## **RIVER ROAD PARK SUBDIVISION**

APPLICATION NUMBER 4 DATE September 16, 2010

REQUEST Subdivision

## DETAIL SITE PLAN

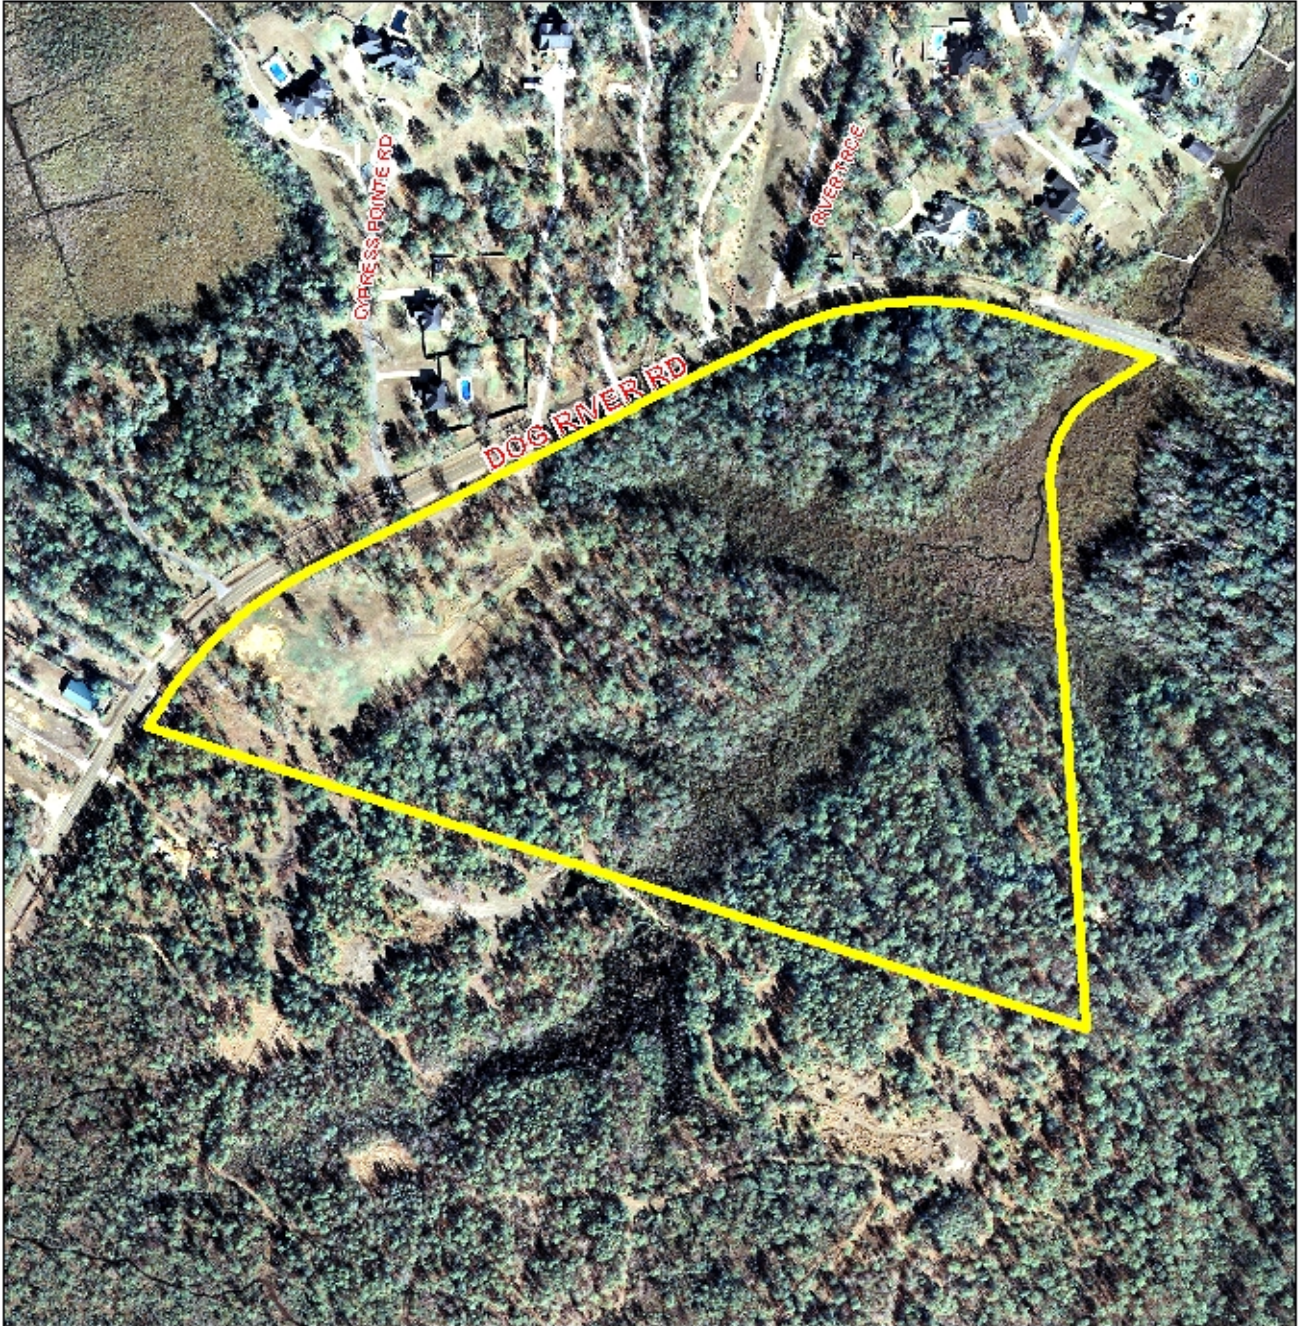
A review of recorded deeds associated with the property indicates a discrepancy between the location of the proposed Lot E for the gas venting station and the plat of the recorded easement and area for the facility. Discussions with the applicants' engineer confirm the discrepancy and the intent to request a holdover to correct the error. Therefore, this application should be heldover to allow the applicants to correct the plat discrepancies.

- 1) revision of the plat to correct the discrepancy between the location of proposed Lot E and the recorded deed and plat for the gas venting station easement and area for facilities, with the revised plat to be submitted no later than September 29.
